Alert Service Bulletin

**CAMERON
BALLOONS**

(a) No.:	13
(b) Revision / Date	Revision 0 / Date 29/10/04
(b)Title:	Cracking of Weld on Triple and Quad Burner Mountings.
(c)Description:	Possible failure of weld at joint between the burner can support plate and mounting tube.
(d)Applicability:	All Shadow, Stealth and Stratus Triple/Quad Burner assemblies with gimballed burners
(e)Effectivity:	All

10. Figure 1:

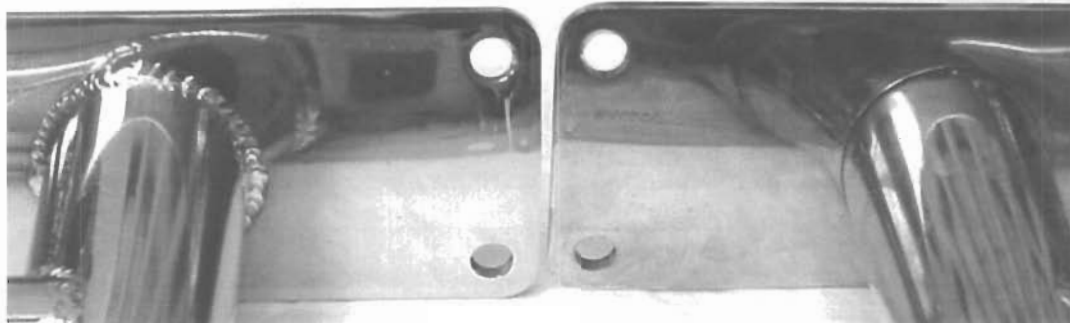
There have been a number of failures during road transport of the weld between the burner can support plate and mounting tube due to insufficient weld bead/fatigue.

Inspect burner mounting bracket for security and correct appearance. Refer to Figure1. Non-conforming/cracked brackets must be replaced. Exchange brackets will be provided together with an instruction sheet for local replacement, or the burner can be returned to the factory. Refer to Cameron Balloons Ltd. for details.

Instructions.
 With the burner cold and all hoses disconnected/vented.
 1) Hold burner by top of coil and check for security of mounting.
 2) Visually inspect joint between burner can support plate and mounting tube. Check for visible weld bead.

Visible Weld Bead Here
 (Four positions on Quad Burner)

Visible Weld Bead Here

Bracket With Correct Weld Bead

Bracket Without Correct Weld Bead

Shadow/Shadow Stealth - Triple Bracket - CB2216, Quad Bracket - CB2252.
Stratus- Triple Bracket CB8592, Quad Bracket -CB8596.
